DOCUMENT 00 90 00
ADDENDUM

ADDENDUM NO. [1] **Date: August 16, 2018**

RE: THE SALVATION ARMY – LA CROSSE
223 8TH STREET NORTH
LA CROSSE, WI 54601
HSR 17068

Project Title:
**THE SALVATION ARMY -
LA CROSSE: INTERIOR
SHELTER REMODEL**

2 FIRE ALARM RISER DIAGRAM

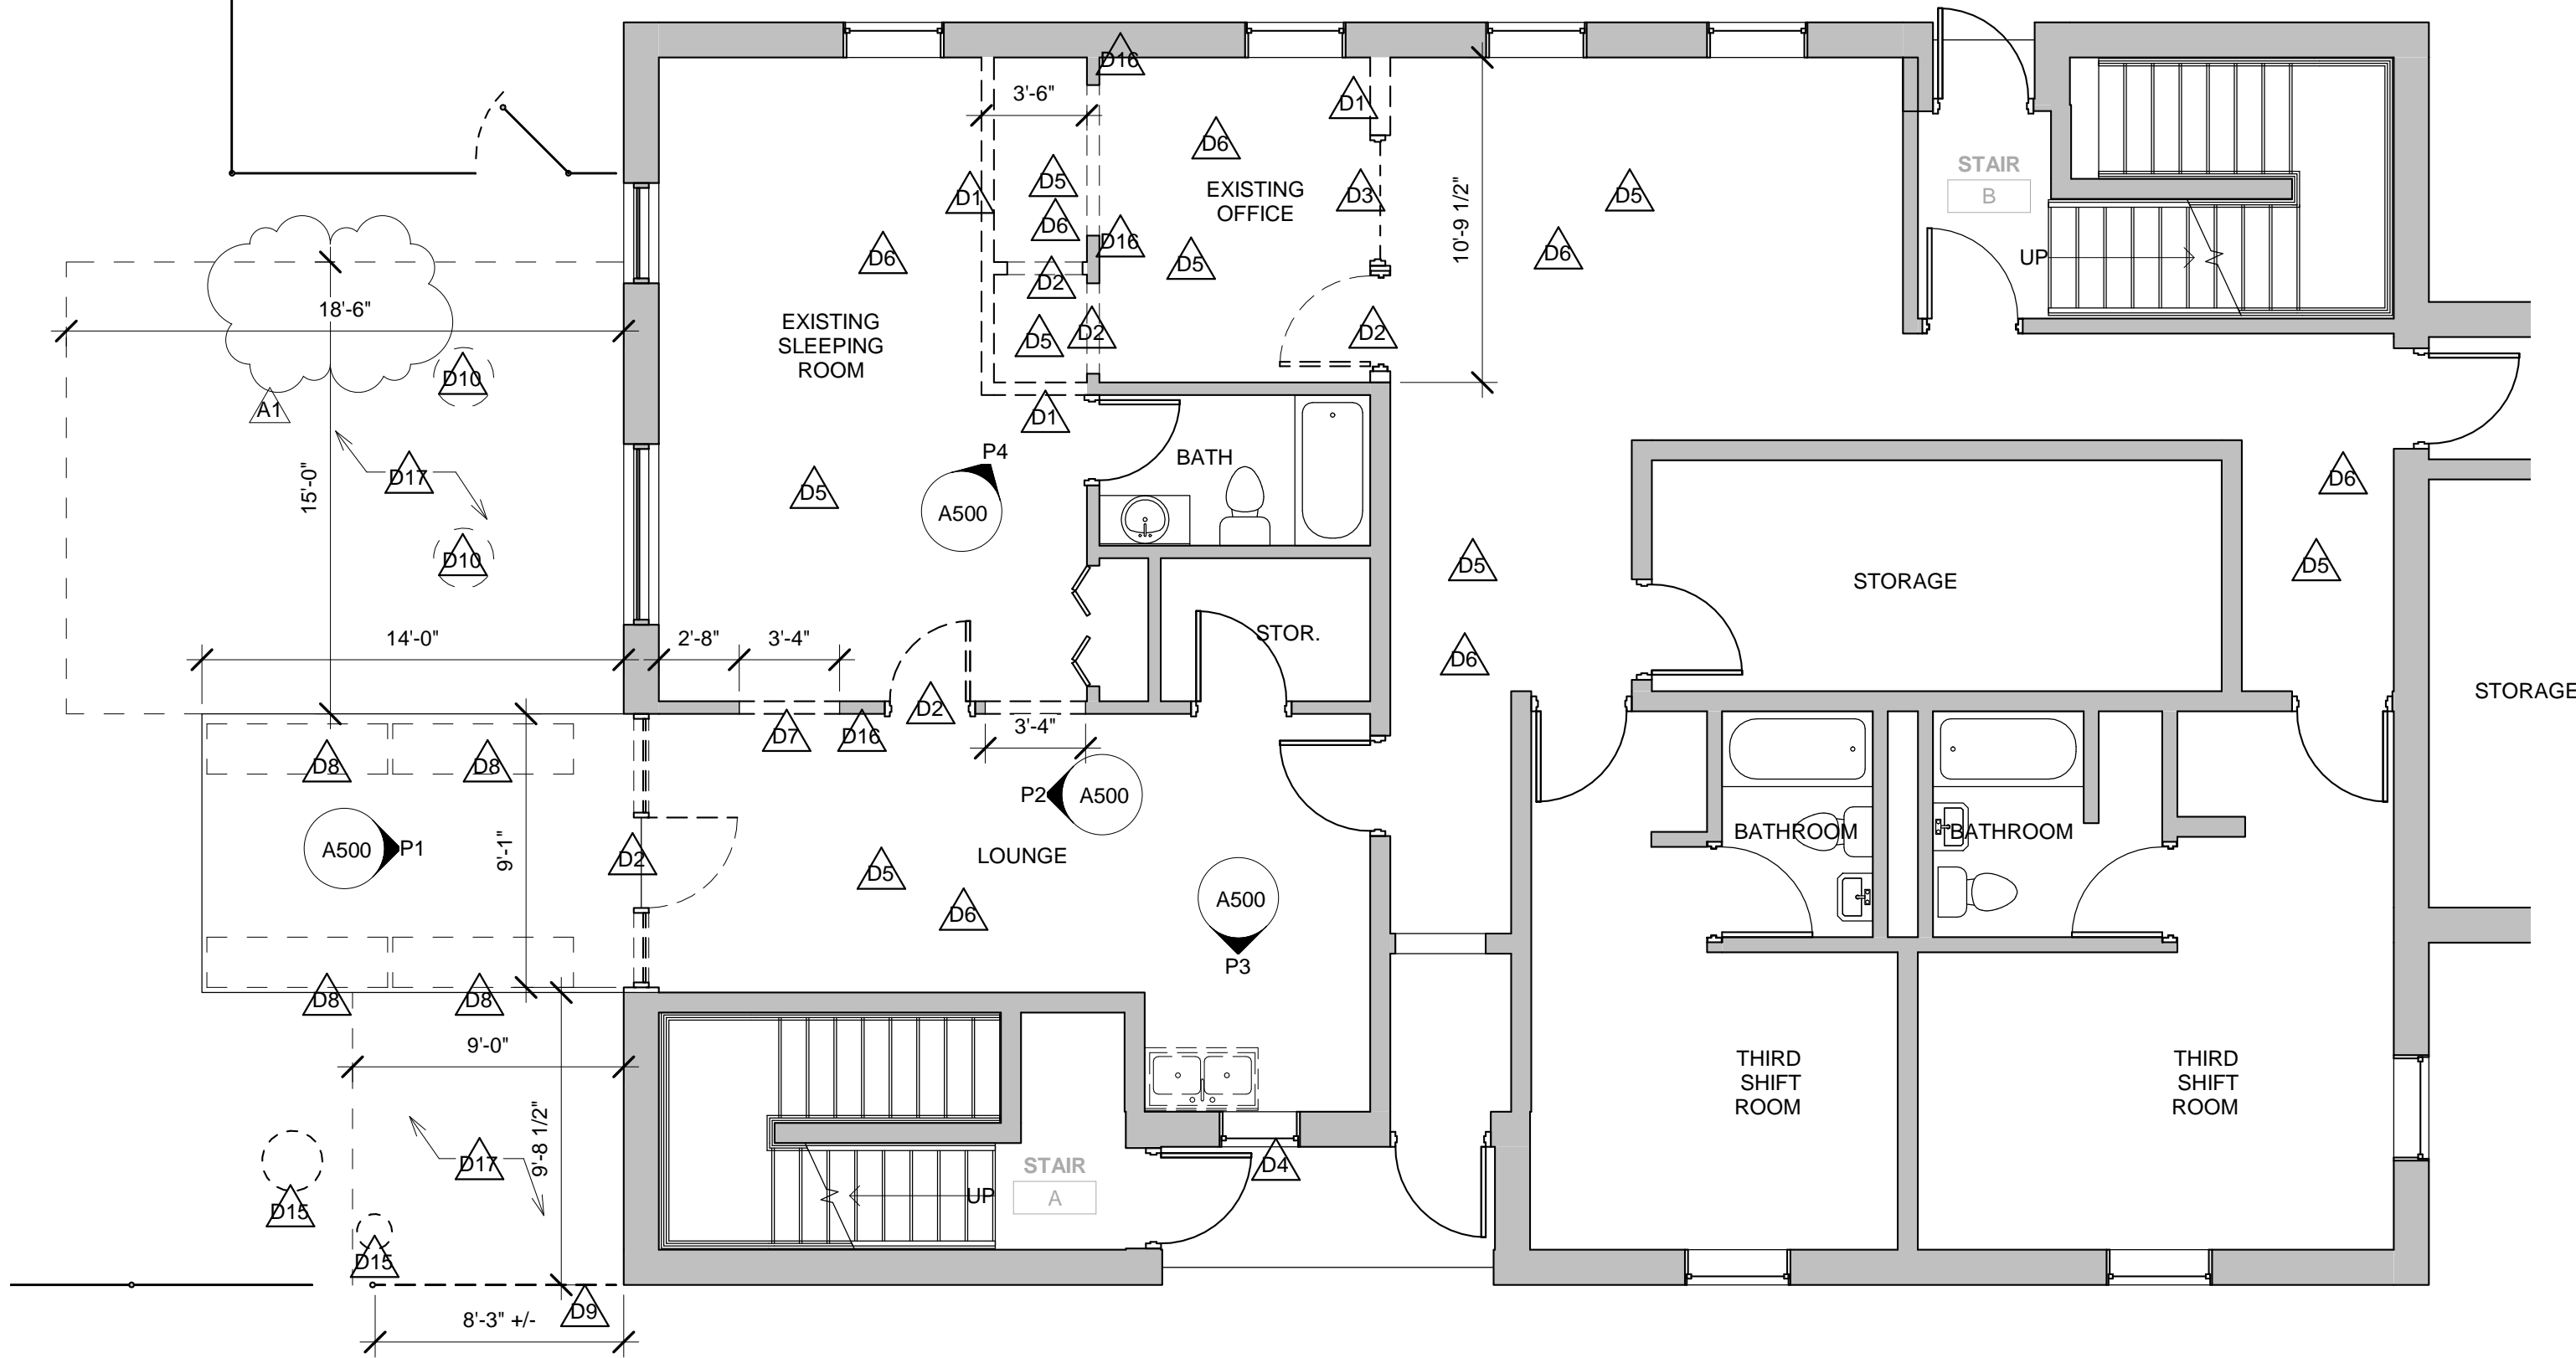
9. Section 28 31 00 FIRE DETECTION AND ALARM
 - a. Existing alarm system from 1990 addition is Edward Fireshield. Refer to attached riser diagram.

1 FIRST FLOOR SHELTER REMODEL PLAN
1/4" = 1'-0"

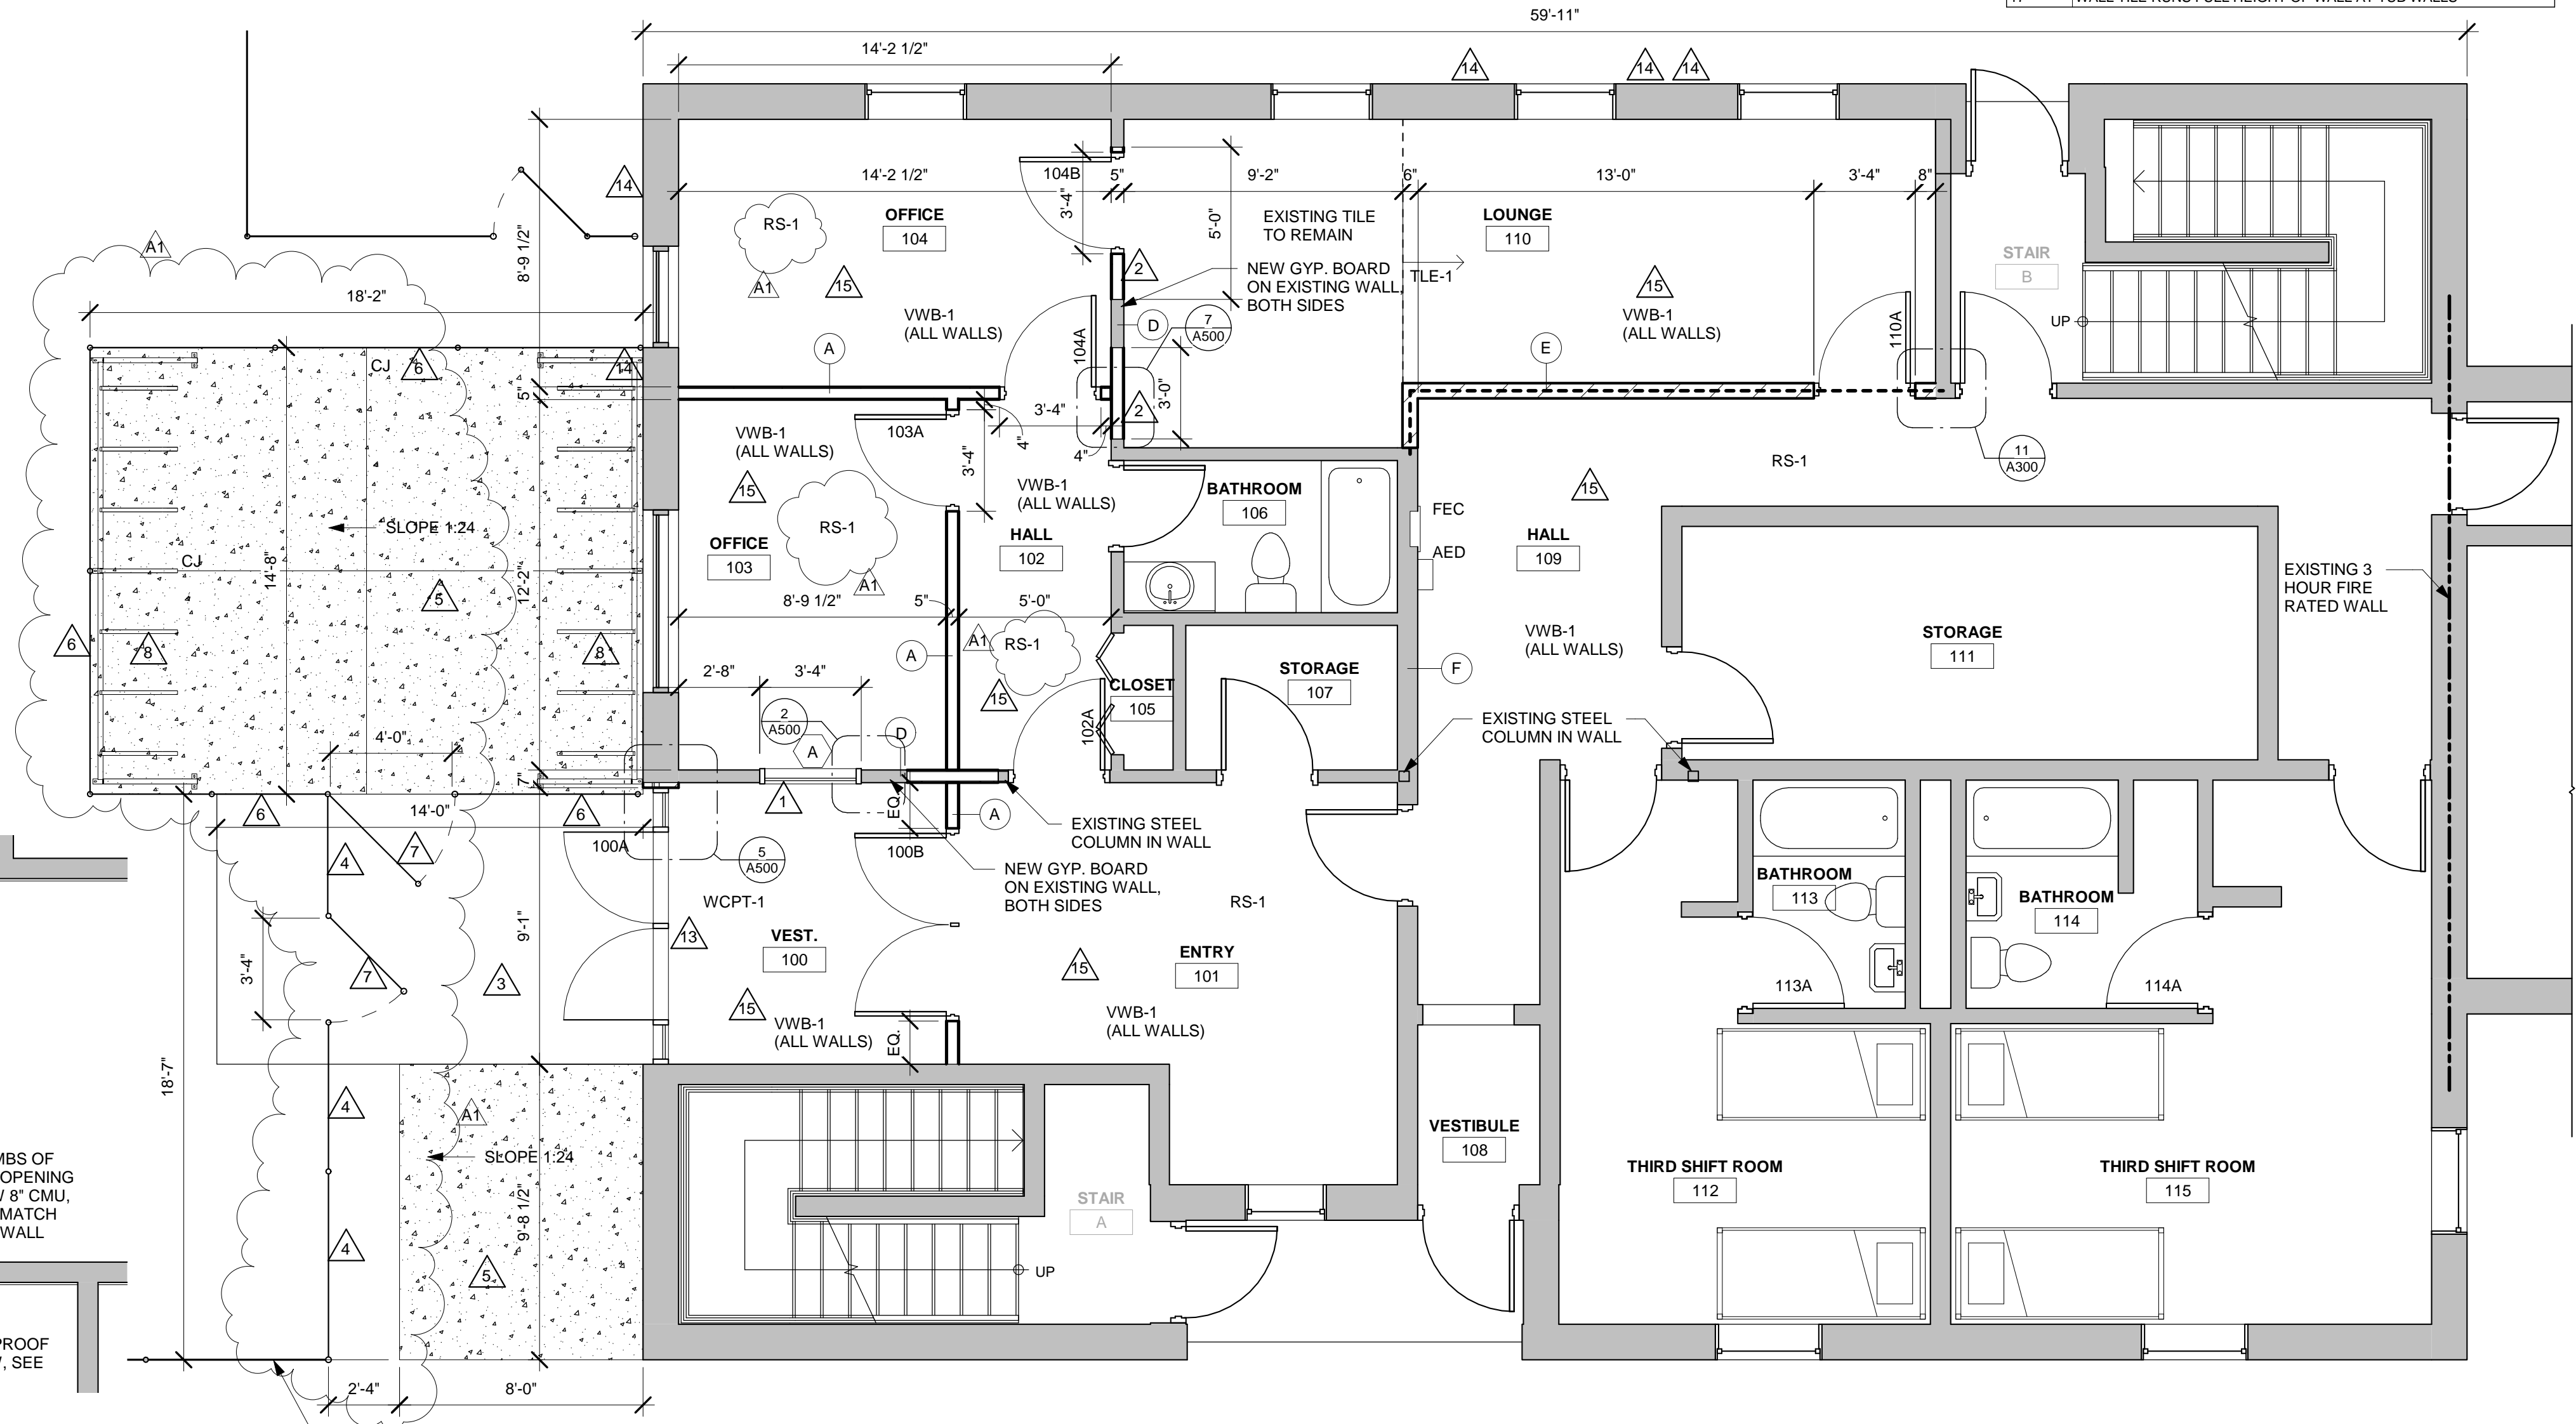
11. Sheet A101R: FIRST FLOOR SHELTER AND REMODEL PLAN: 24x36 attached hereto
 - a. The bicycle storage area concrete slab has been widened. The chain-link fence and lid are adjusted accordingly.
 - b. The existing flooring in Hall #102, Office #103 and Office #104 will be removed and replaced with RS-1.
